# Planning Commission Agenda Item

**SUBJECT: ZN-20-2024 CENTENNIAL LOSEE (Public Hearing).** Applicant: Greystone Nevada, LLC. Request: A Property Reclassification from a PUD, Planned Unit Development District to a PUD, Planned Unit Development District, Consisting of 288 Multi-Family Dwelling Units. Location: Northwest Corner of Losee Road and Azure Avenue. (APNs 124-26-501-019 and 124-26-501-020) Ward 2. (For Possible Action) (***Continued from January 8, 2025***)

**RECOMMENDATION: RECOMMEND TO APPROVE WITH CONDITIONS**

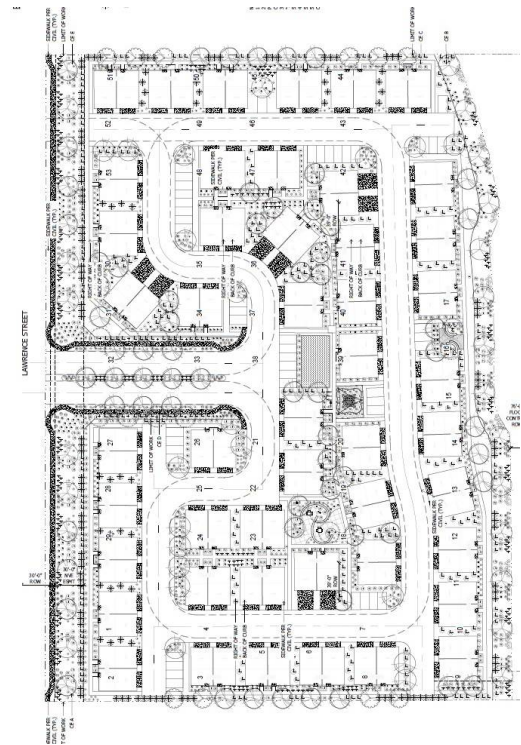
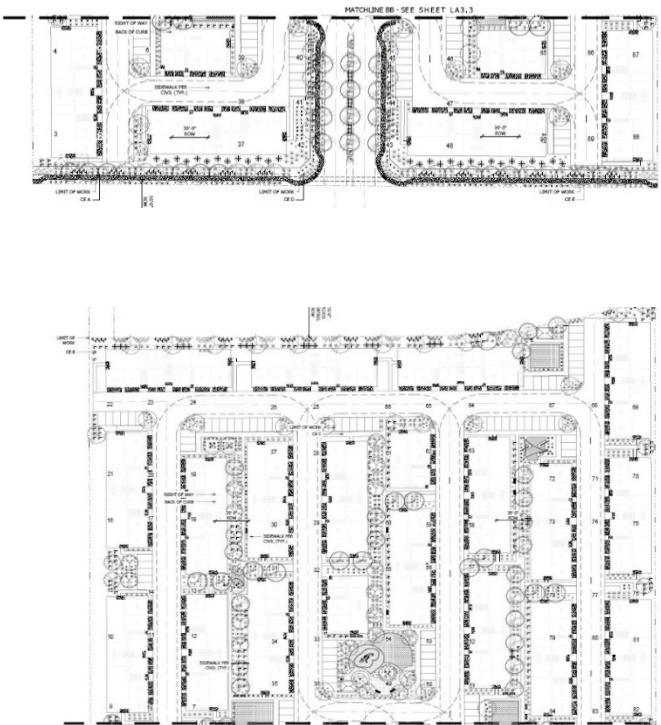
The proposed landscaping plan indicates the perimeter landscaping of 35 feet along North Lawrence Street including a five (5) foot sidewalk. There is an existing City water line along Lawrence Street, which creates the need for the wider landscaping where the required perimeter landscaping along North Lawrence Street is fifteen (15) feet including a five (5) foot sidewalk. The required perimeter landscaping along Losee Road is twenty (20) feet including a five (5) foot sidewalk. The proposed landscape plan complies with this requirement. The perimeter landscaping appears to be in compliance with code requirements. The proposed landscape plan indicates a view fence is provided along the trail/wash area for both the west and east portions of the development.

The proposed west development area will contain duplexes 41 feet long and 46.83 feet wide with a five (5) foot rear driveway to access the two (2)-car garage. The driveways will be required to be a decorative brick to distinguish the difference between the drive aisle and the driveway and to enhance the alleyway with a decorative element. The drive aisles will be 34 feet wide with five (5) feet of sidewalk on each side. In addition, there is a walking path throughout this portion of the development. The sidewalk should be widened to seven (7) feet, which is consistent with similar PUD developments. This should enhance the comfort for residents when using the pathway.

The west portion of the proposed PUD development is required to provide 57,600 The applicant has provided three (3) small park areas for a total of 4,511 square feet of useable open space within the development as well as sidewalk pathways. The sidewalks should be increased to seven (7) feet wide for residents comfort. Only private open space with a width of 20 feet or more can be counted towards this requirement. The proposed site is located near the Centennial-Lawrence Trailhead immediately to the north. This public park can be considered an amenity to the development. The code allows developments within five hundred (500) feet of an improved public park, plaza, or other open space and connected by a continuous sidewalk meeting the Americans with

Disabilities Act may be approved with reduced open space areas within the project. This project is adjacent to the park north of the development using Lawrence Street. The applicant should also provide pedestrian access to the existing trail from the eastern portion of the proposed PUD. The proposed park amenities for the west development have been identified as; turf area, tot lot with EPDM surfacing, shade sail, picnic table, ramada, benches, game table, trash receptacles and dog waste stations. The amenities should be confirmed with the Final Development Plan.

3. All driveways within the west portion single-family duplex shall have brick driveways.
4. All pathways within both developments shall be 7 feet wide.
5. The following amenities shall be provided within the open space areas: turf area, age appropriate playground equipment with EPDM surfacing, shade sail, picnic table. Ramada, benches, game table, trash receptacles and dog waste stations.
